Charlotte-Mecklenburg Planning Department

SUBJECT: Administrative Approval for Petition No. 2008-031 Mountain Island Promenade, LLC

PETITION #:2008-031
REZONING SCHEMATIC SITE PLAN C

Title: **SITE PLAN FOR PHASE 1**

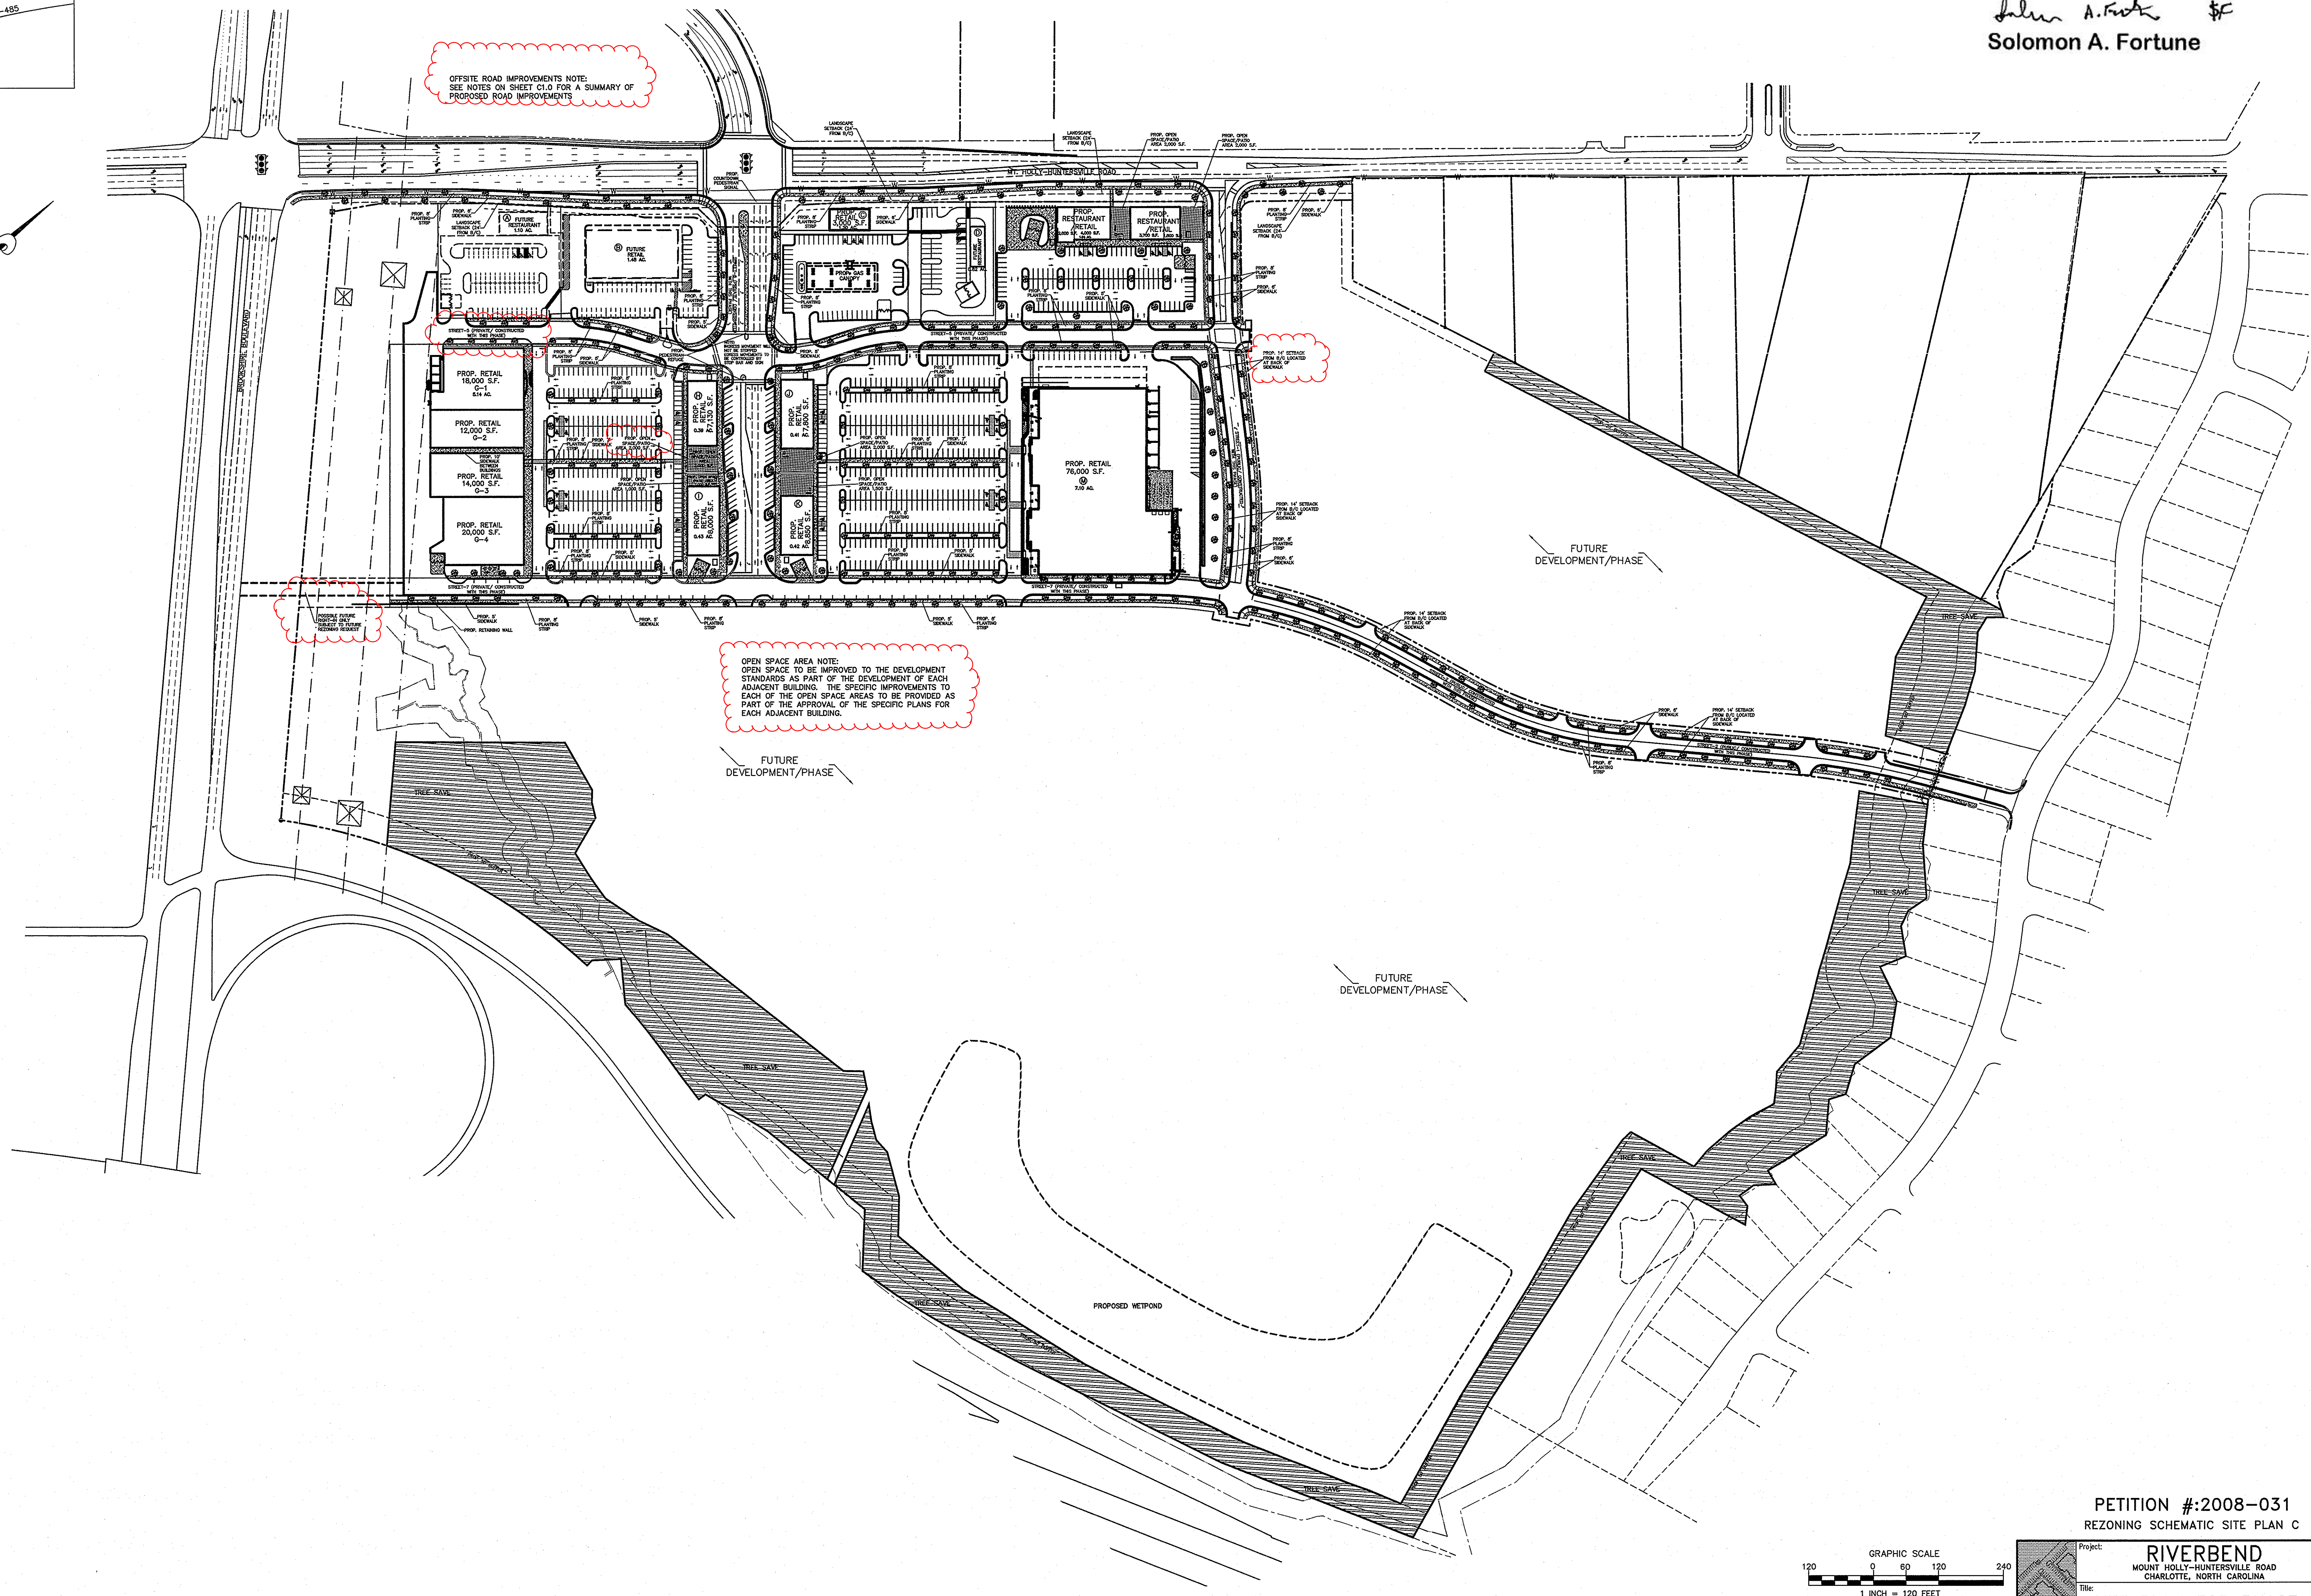
Attached is the revised site plan for the petition above. This request allows the modification of the proposed site plan as listed below. Since these changes do not alter the intent of the development and meets the requirements of the Charlotte Zoning Ordinance Section 6.207 Alterations to Approval, minor changes, I am administratively approving this plan. Please use these plans when evaluating requests for building permits and certificates of occupancy.

- General layout for proposed retail buildings.
- Note modification: Elevation and review will happen prior to commercial building standards review.
- Master site development record
- Open space and green areas are tied to certain buildings being developed.
- Screening wall along proposed internal public street

Title: **SITE PLAN FOR PHASE 1**

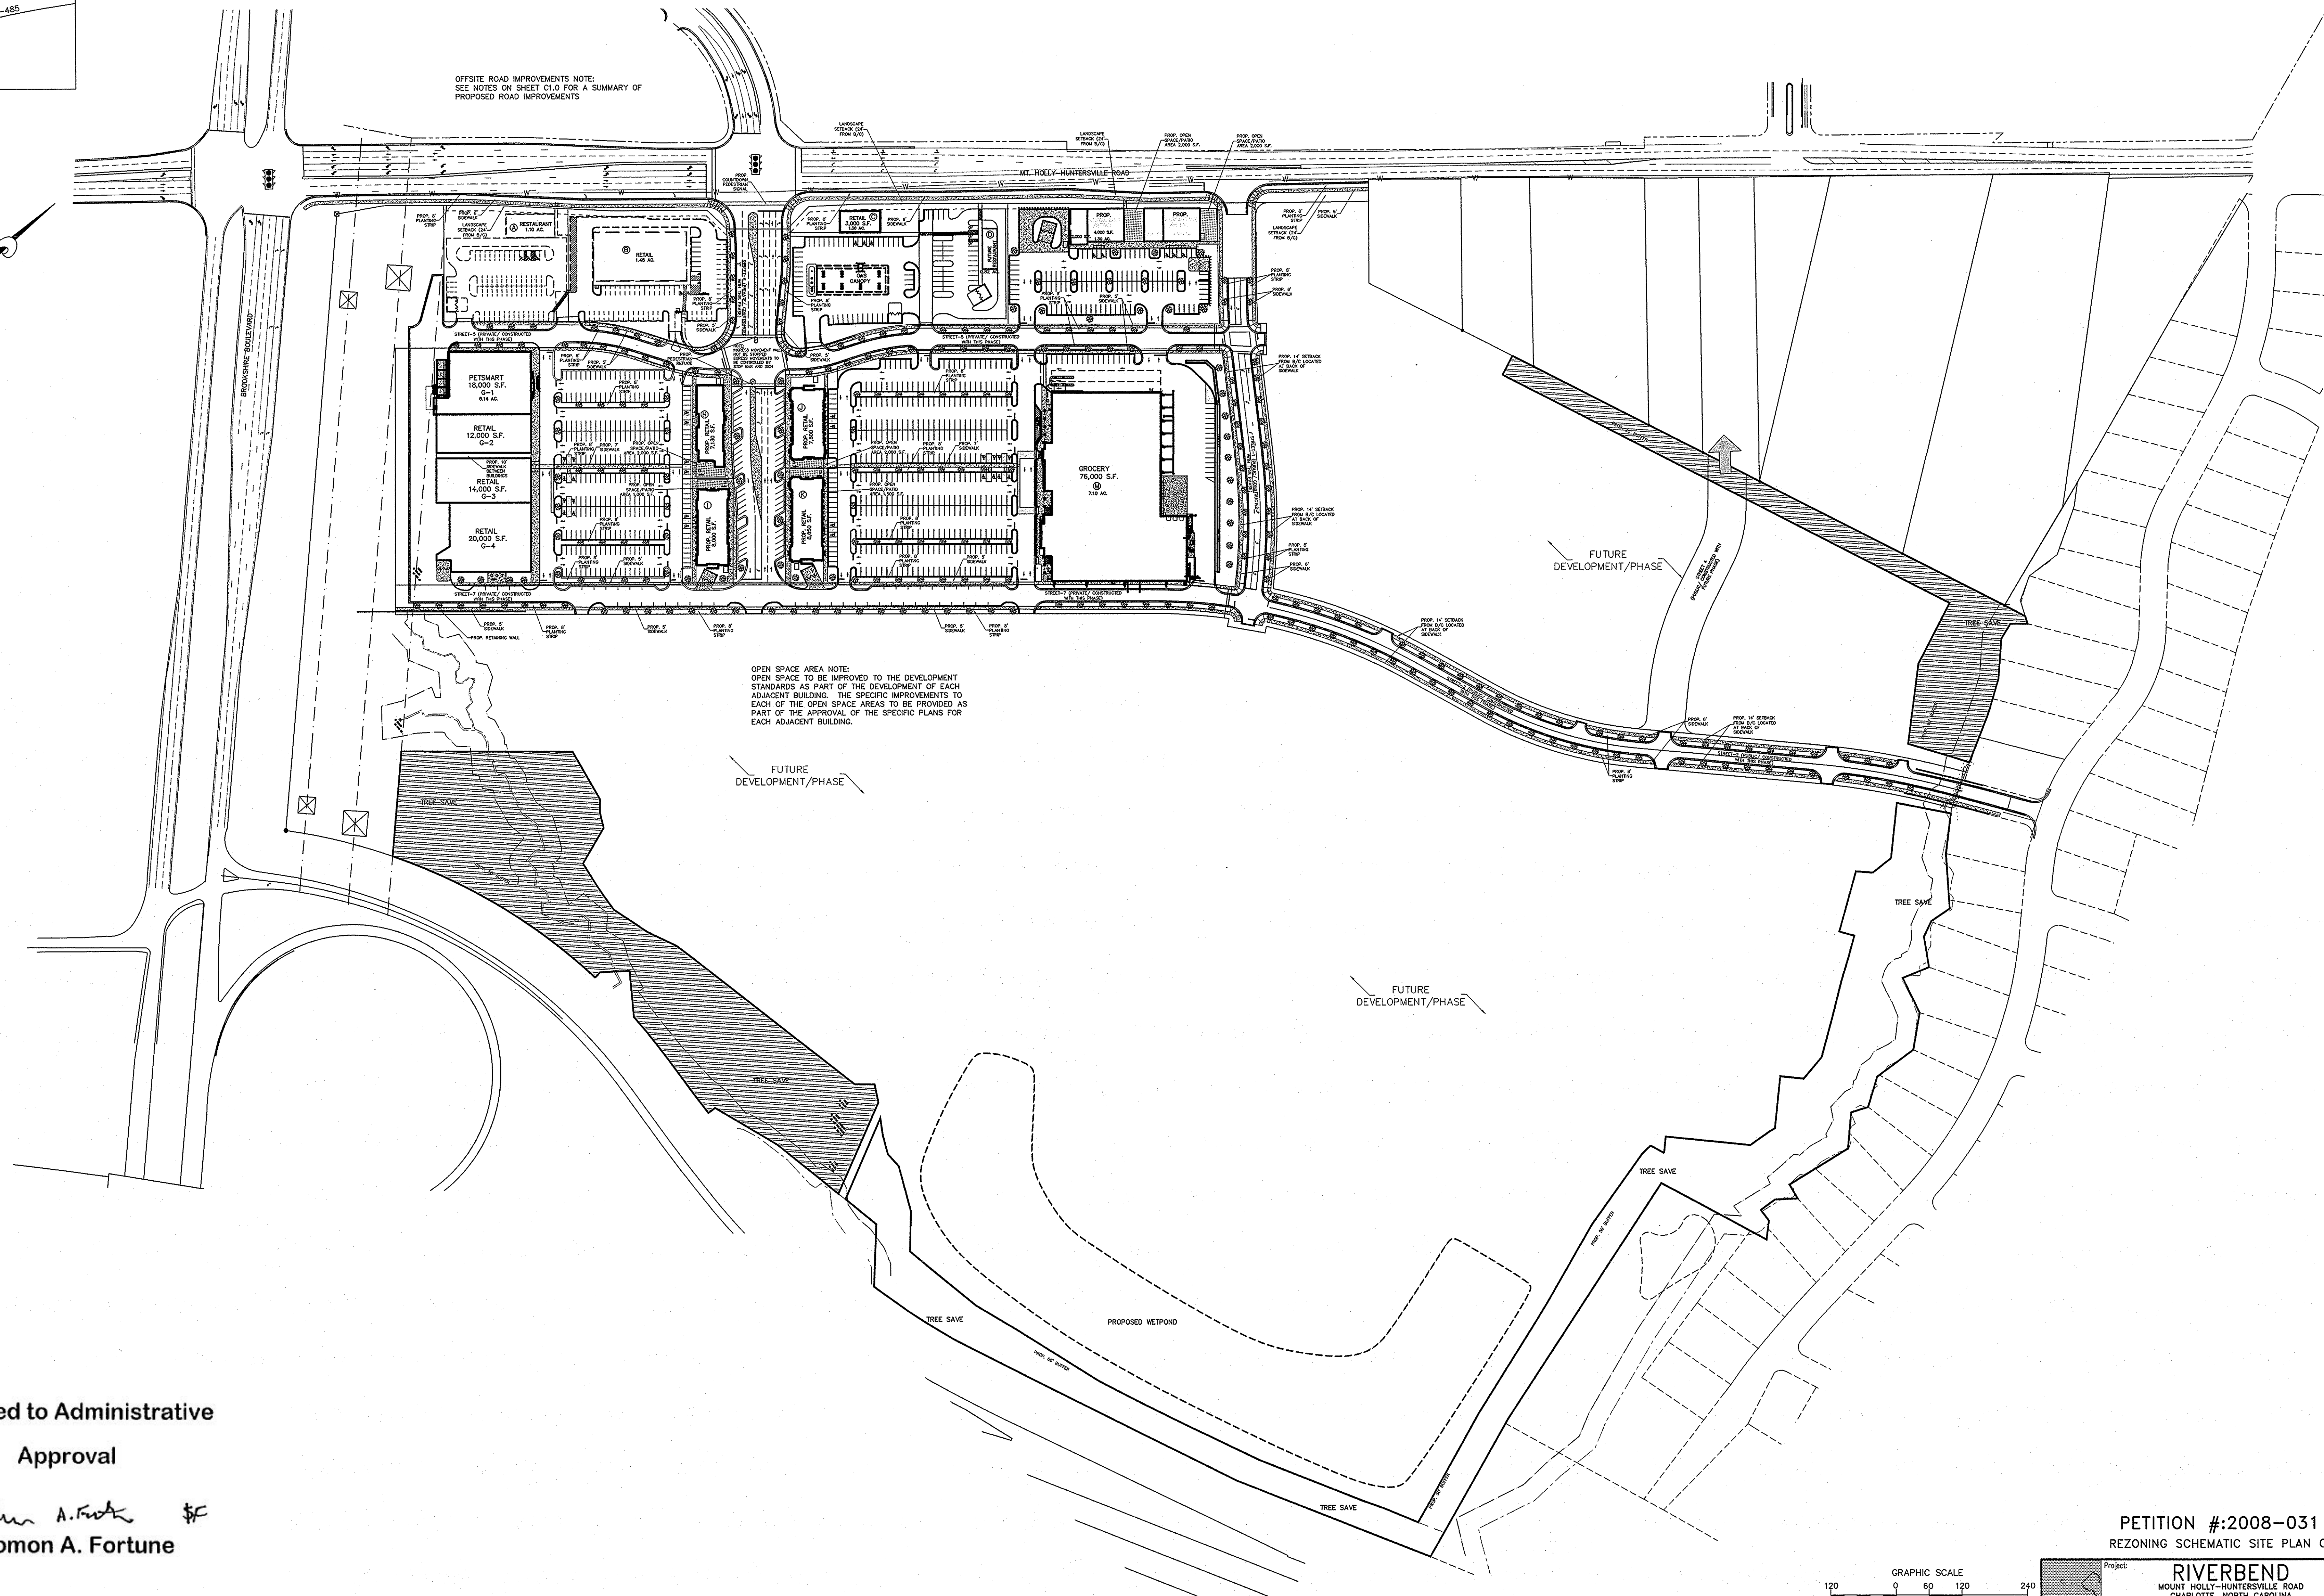
Attached is the revised site plan for the petition above. This request allows the modification of the proposed site plan as listed below. Since these changes do not alter the intent of the development and meets the requirements of the Charlotte Zoning Ordinance Section 6.207 Alterations to Approval, minor changes, I am administratively approving this plan. Please use these plans when evaluating requests for building permits and certificates of occupancy.

- General layout for proposed retail buildings.
- Note modification: Elevation and review will happen prior to commercial building standards review.
- Master site development record
- Open space and green areas are tied to certain buildings being developed.
- Screening wall along proposed internal public street

Please note that no elevation review was completed as part of this review and approval. Each site will need to submit site layout, elevations, and landscaping plan, master development record as each building is developed. Zoning and conditional requirements will be reviewed as each site comes in for development.
